September 30, 2022

Re: Federal Life Lexington Home Development  
Preliminary Site Development

**FIELD INVESTIGATION EXHIBIT**  
**LEXINGTON RIVERWOODS**  
**3750 DEERFIELD ROAD**  
RIVERWOODS, ILLINOIS

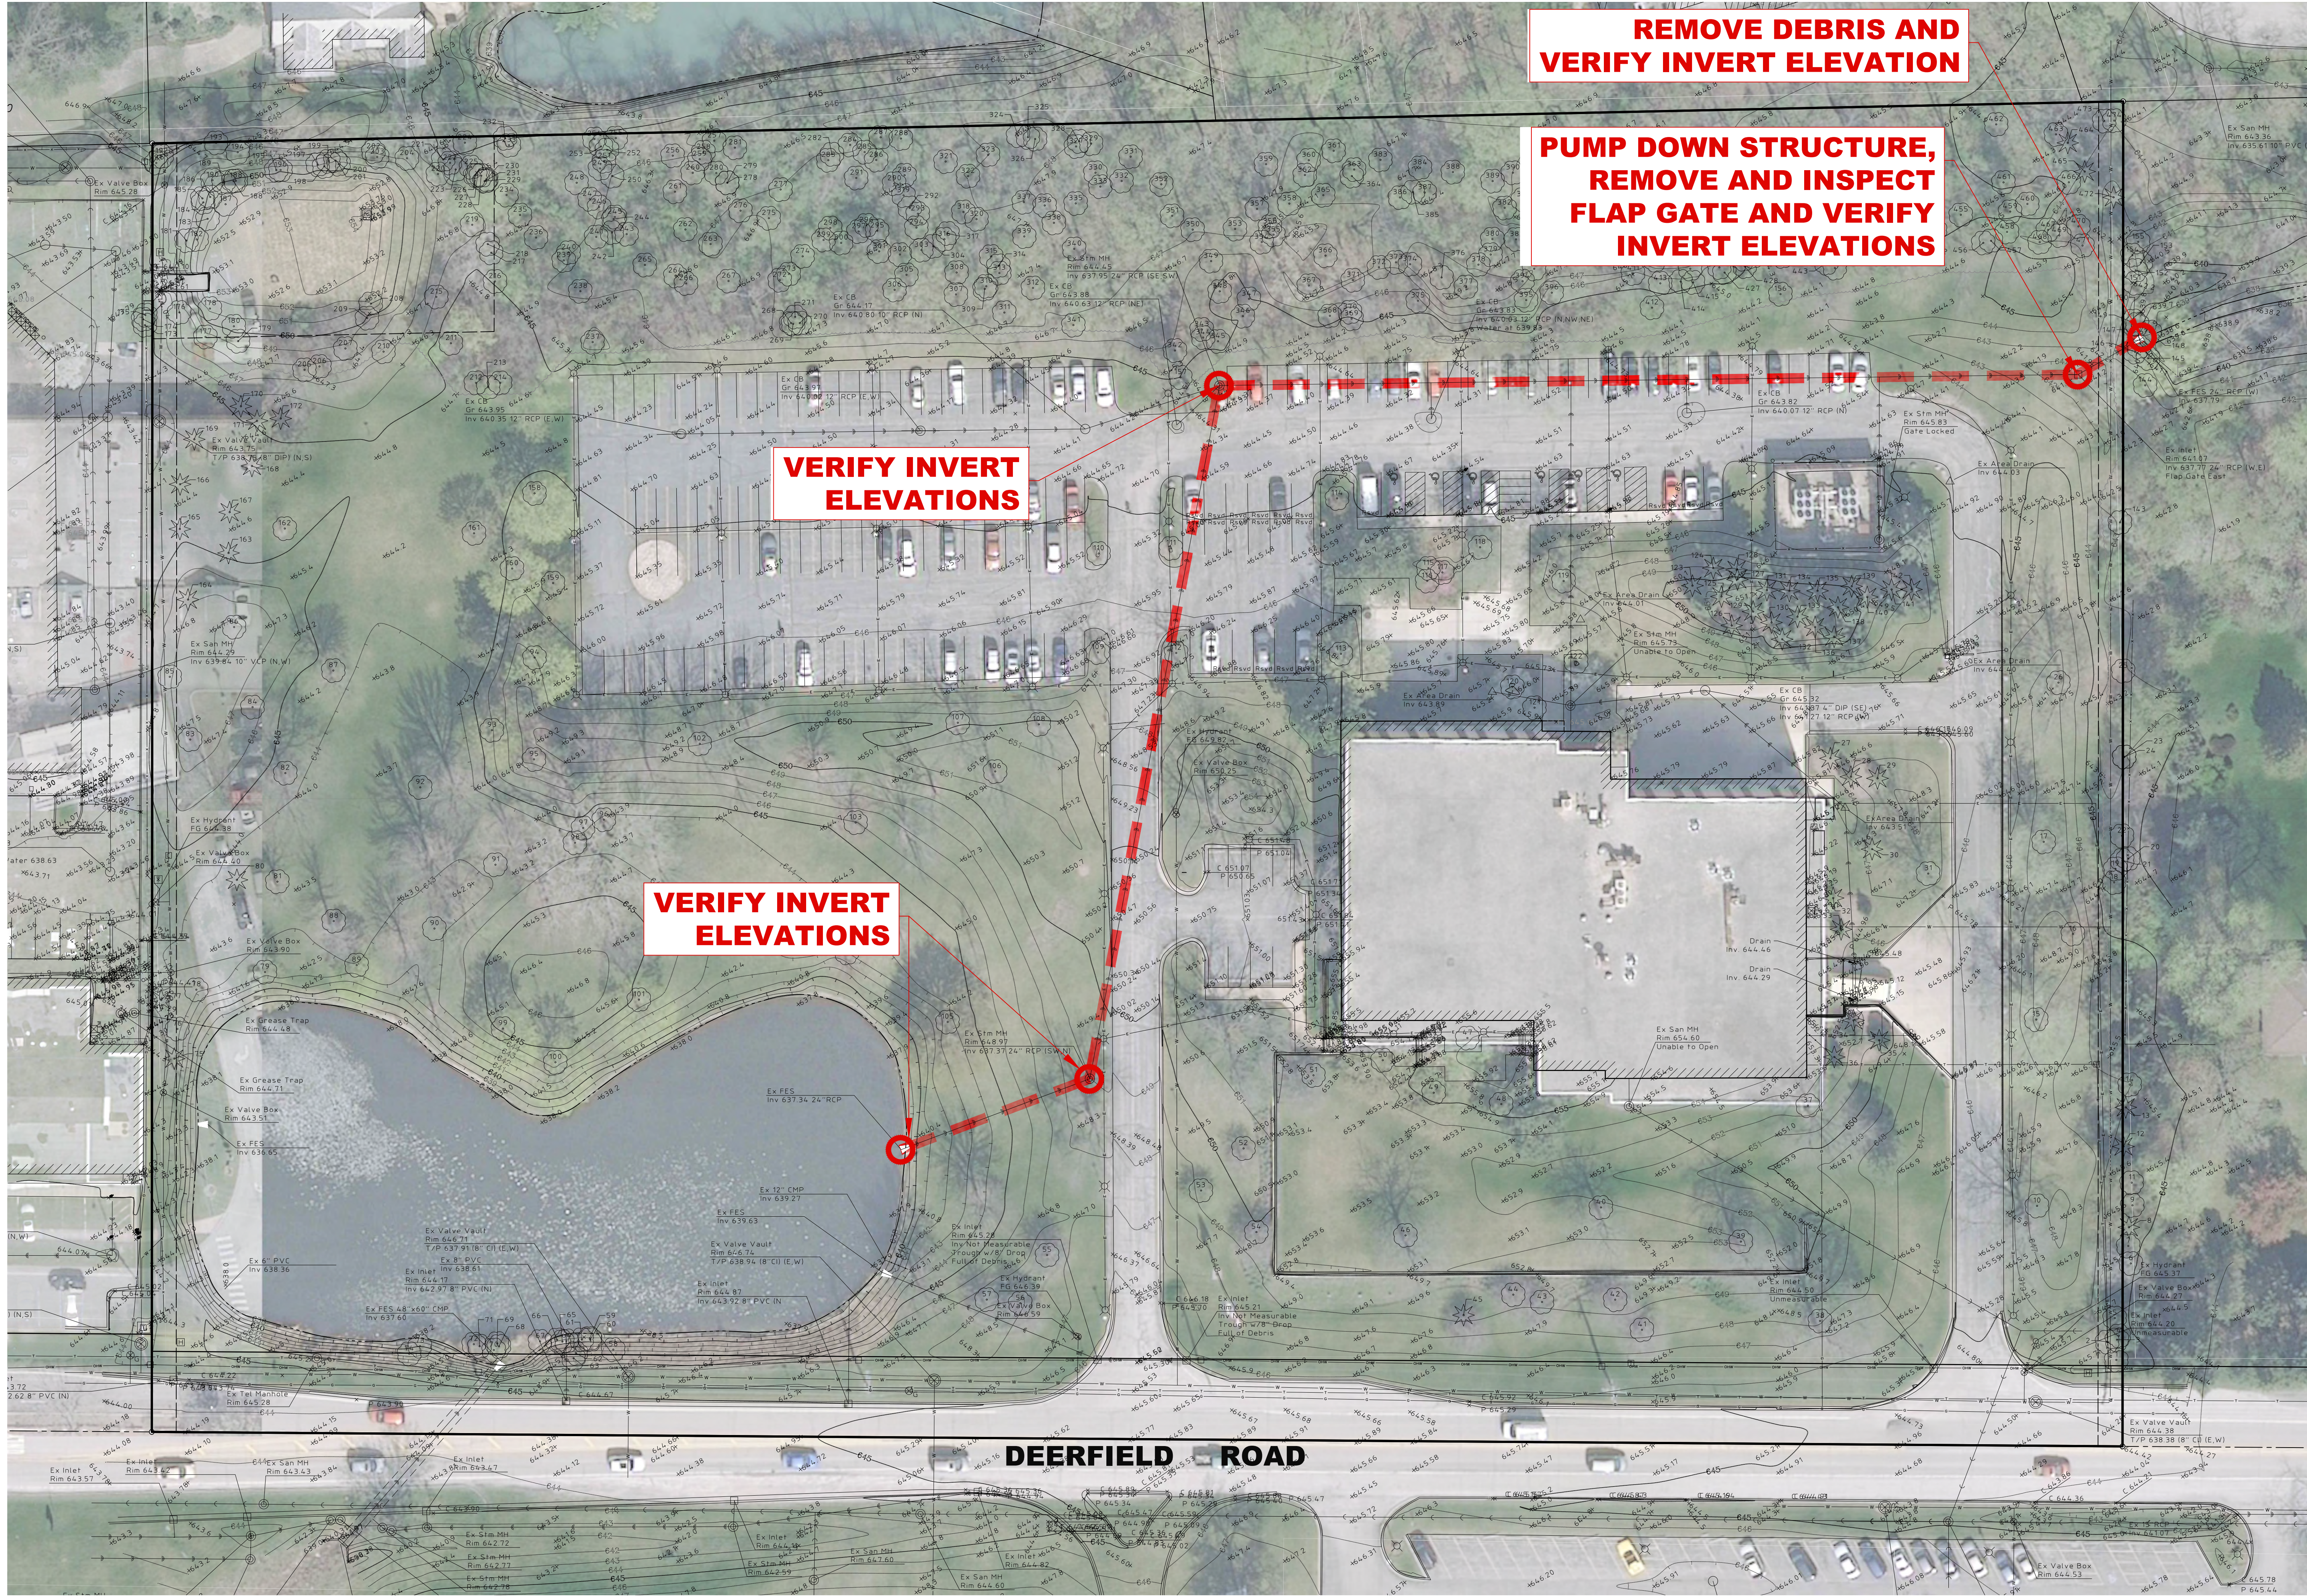
3. Per the email correspondence from Haeger Engineering on July 25, 2022, Haeger was planning to conduct an additional field investigation and submit further documentation and findings in regard to invert elevations along the outfall sewer and the outlet control structure, including the 6" bypass pipe/opening. Attached is the Field Investigation Exhibit that was included with the correspondence. It appears there have been no updates to this on the survey in the plans. Another open item regarding this matter includes addressing elevation discrepancies as noted by CBBEL's email on March 17, 2022. The Village cannot concur a NWL of 638 and the existing conditions HWL until after the field work is completed and the modeling is updated.

**REMOVE DEBRIS AND  
VERIFY INVERT ELEVATION**

**PUMP DOWN STRUCTURE,  
REMOVE AND INSPECT  
FLAP GATE AND VERIFY  
INVERT ELEVATIONS**

**VERIFY INVERT  
ELEVATIONS**
